DOMINION NUCLEAR NORTH ANNA, LLC
NORTH ANNA EARLY SITE PERMIT APPLICATION
FINAL SAFETY EVALUATION REPORT REVIEW ITEMS AND REVISION 5 TO THE
NORTH ANNA ESP APPLICATION

Final Safety Evaluation Report Review Items

**Description of Changes in Revision 5
North Anna Early Site Permit Application**

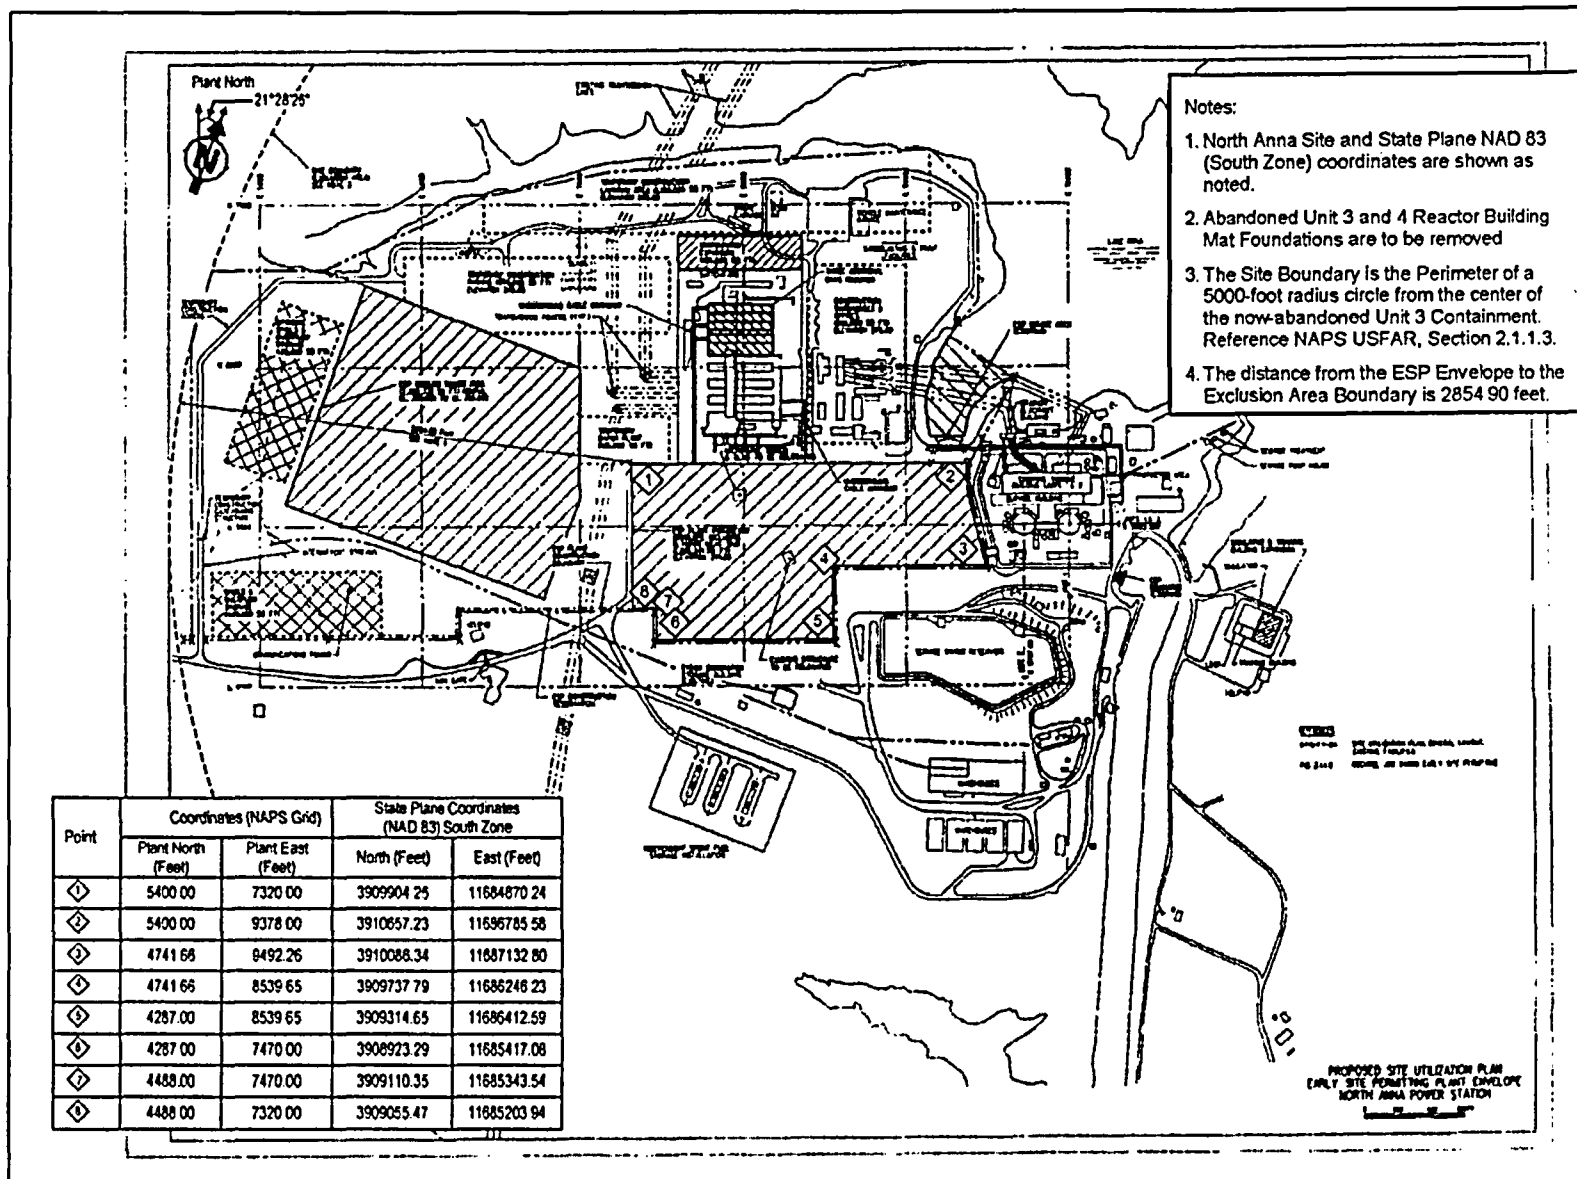
Coordinates for the ESP site footprint were submitted to the NRC in response to Draft Safety Evaluation Report (DSER) Open Item 2.4-1 (Dominion Letter 05-785B dated March 3, 2005).

As discussed in a July 5, 2005 conference call with NRC Staff, upon further review, it has been determined that the coordinates identified in Figure 1 of the DSER Open Item 2.4-1 response contained errors.

A corrected version of Figure 1 is provided on the next page.

None. Figure 1 on the next page is not included in the North Anna ESP Application.

Figure 2.5-55A Selected Horizontal and Vertical OBE and SSE Spectra for the Hypothetical Rock Outcrop Control Point at the Top of Zone III-IV Material (Representative Elevation 250 ft, 3300 ft/sec Shear Wave Velocity)

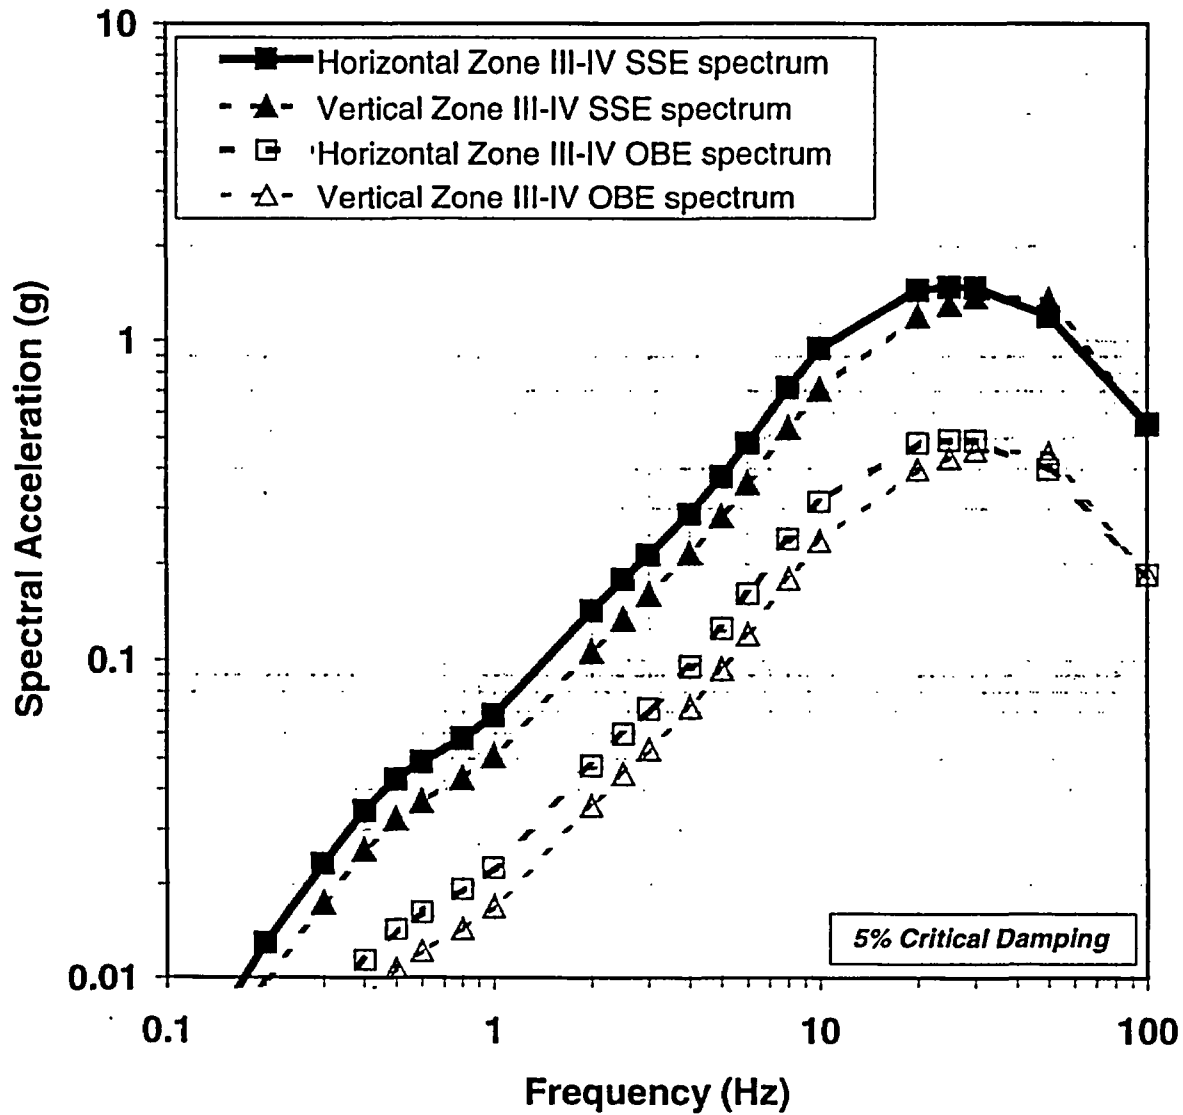
Revision 4 of the North Anna ESP Application included an incorrect version of SSAR Figure 2.5-55A. (A duplicate copy of SSAR Figure 2.5-55 was inadvertently included as SSAR Figure 2.5-55A.)

The correct version of SSAR Figure 2.5-55A has been incorporated in Revision 5 of the ESP Application.

In Revision 5 of the ESP Application, SSAR Figure 2.5-55A has been replaced with the correct version shown on the next page.

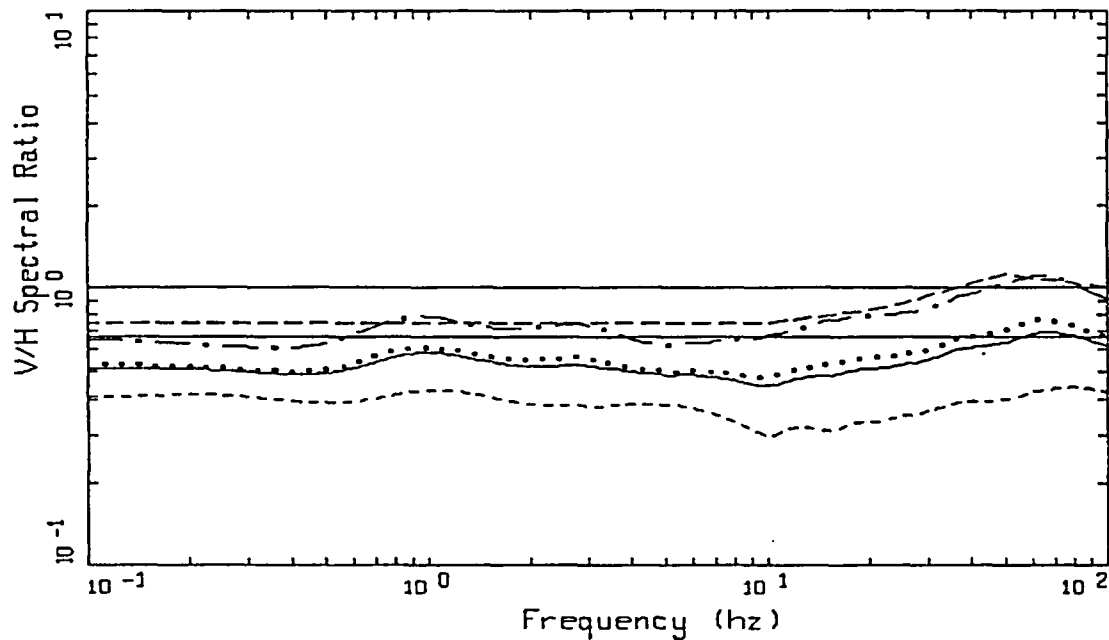
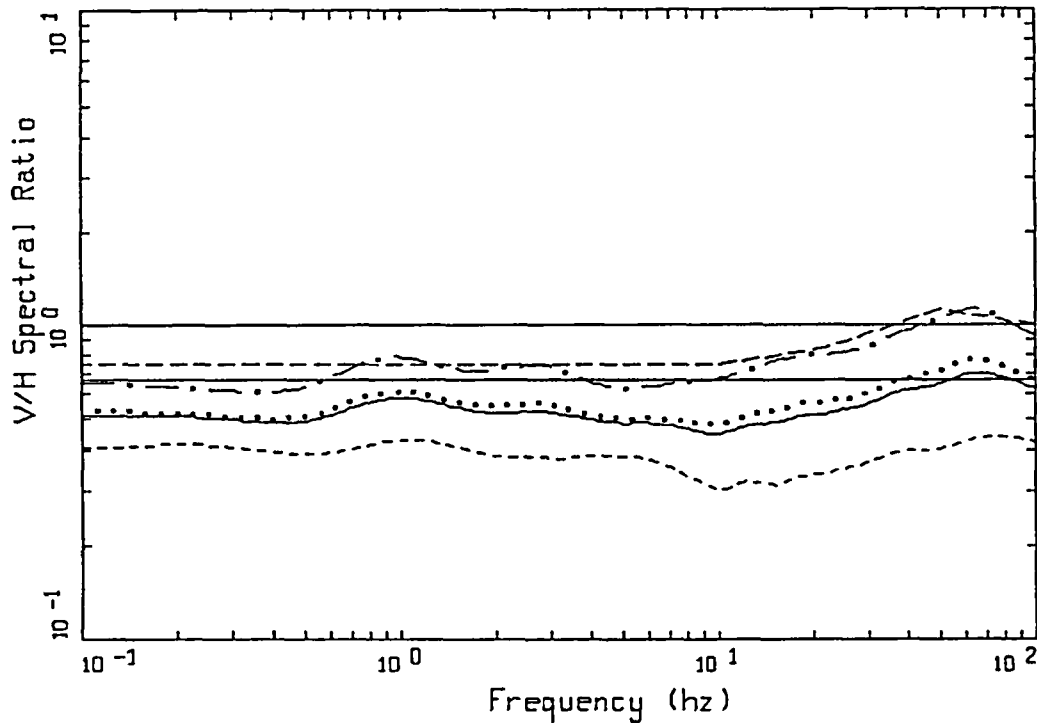
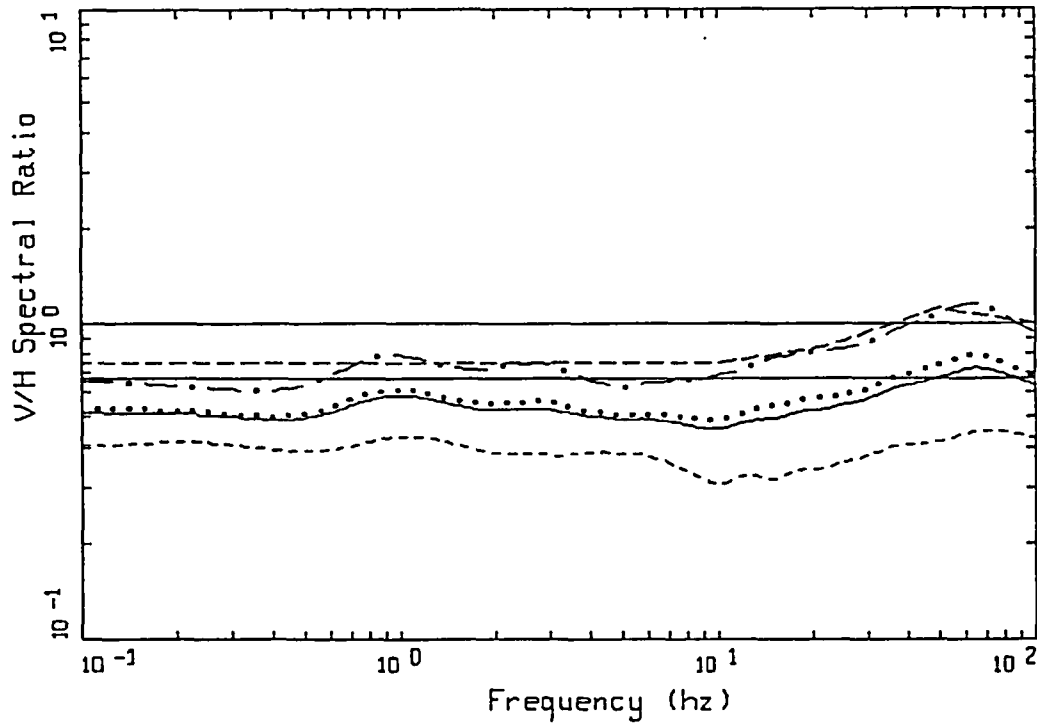
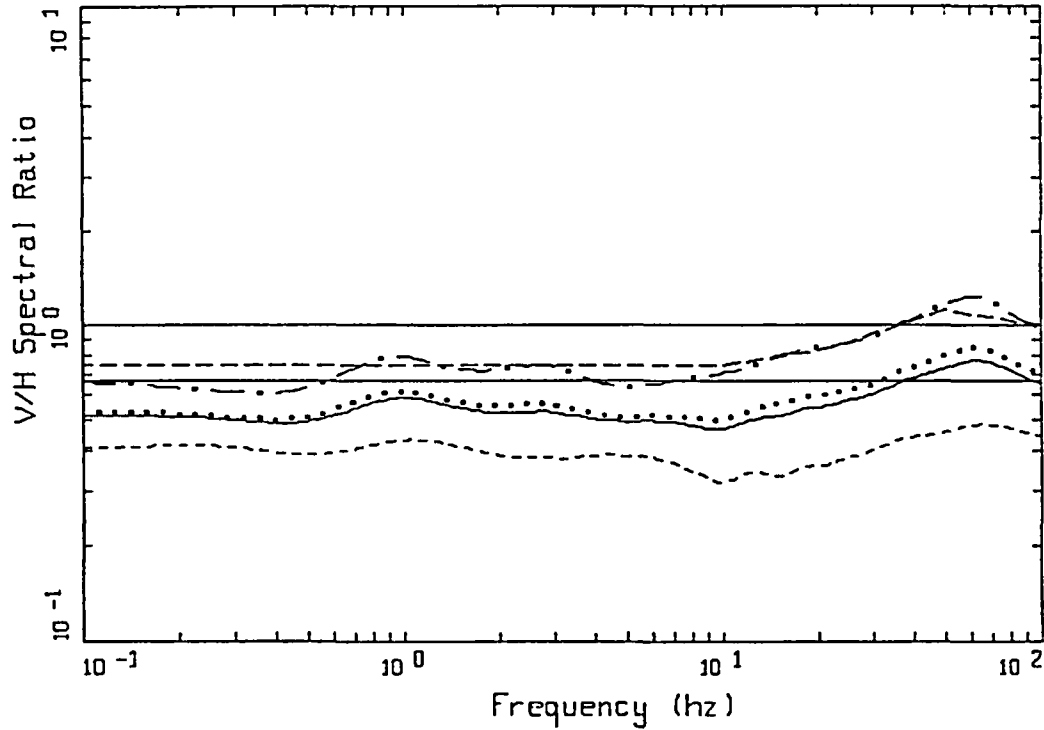
As discussed in a July 14, 2005 conference call with NRC Staff, upon further evaluation, it has been determined that the NUREG/CR-6728 V/H ratios apply explicitly to hard rock conditions with a shear wave velocity of 9,200 ft/sec. The NUREG/CR-6728 V/H ratios are not explicitly appropriate for the site-specific shear wave velocity profile and controlling earthquake magnitude and distance for the North Anna ESP site.

A site-specific analysis has been performed to investigate the appropriateness of the V/H ratios listed in SSAR Table 2.5-27A for the characteristics of the North Anna ESP site. A description of the site-specific analysis is provided in the following section.

The statistical results of the V/H spectral ratios for the 0.5% damping level are shown in Figure 2. For comparison purposes, the V/H ratio for the 0.2g<PGA<0.5g bin from NUREG/CR-6728, which was used in SSAR Table 2.5-27A, is shown in Figure 2.

Similar plots for the additional damping levels of 1.0, 2.0, and 5.0% are shown in Figures 3, 4, and 5. The results for the base case damping level of 2.0% are tabulated in Table 2 for the 21 frequencies used in SSAR Table 2.5-27A.

The 16th, 50th, and 84th percentiles and mean V/H ratios are shown in Figure 4 for the 2.0% damping case and listed in Table 2. For comparison, the V/H ratios from NUREG/CR-6728 for the $0.2g < PGA < 0.5g$ case, which was used for SSAR Table 2.5-27A, are also shown in Figure 4 and listed in Table 2. On average, the mean V/H ratios from the site-specific analysis are approximately 30% lower (ranging from 18-35% lower) over the complete frequency range of 100 Hz to 0.1 Hz than the V/H ratios used in SSAR Table 2.5-27A. At the 84th percentile, the site-specific V/H ratio values are on average 8% lower (ranging from 19% lower to 5% higher) over the entire frequency range than the SSAR Table 2.5-27A V/H ratio values.

In Revision 5 of the ESP Application, SSAR Section 2.5.2.6.7.d has been revised to read as follows:

The results of the site-specific analysis confirm the appropriateness of the V/H ratios listed in Table 2.5-27A. Compared with the Table 2.5-27A values, the mean V/H ratios from the site-specific analysis are, on average, approximately 30% lower (ranging from 18-35% lower) over the complete frequency range of 100 Hz to 0.1 Hz. At the 84th percentile, the site-specific V/H ratio values are on average 8% lower (ranging from 19% lower to 5% higher) over the entire frequency range than the Table 2.5-27A V/H ratio values.

The comparison results provide justification that the V/H ratios given in Reference 171 and used in Table 2.5-27A are appropriate for the North Anna ESP site. To maintain a hazard-consistent level in scaling the horizontal ground motions, the fractile level needed for the V/H ratio is between the 50th and 84th percentile. The exact percentile level would depend on frequency, site, design considerations, and judgment.
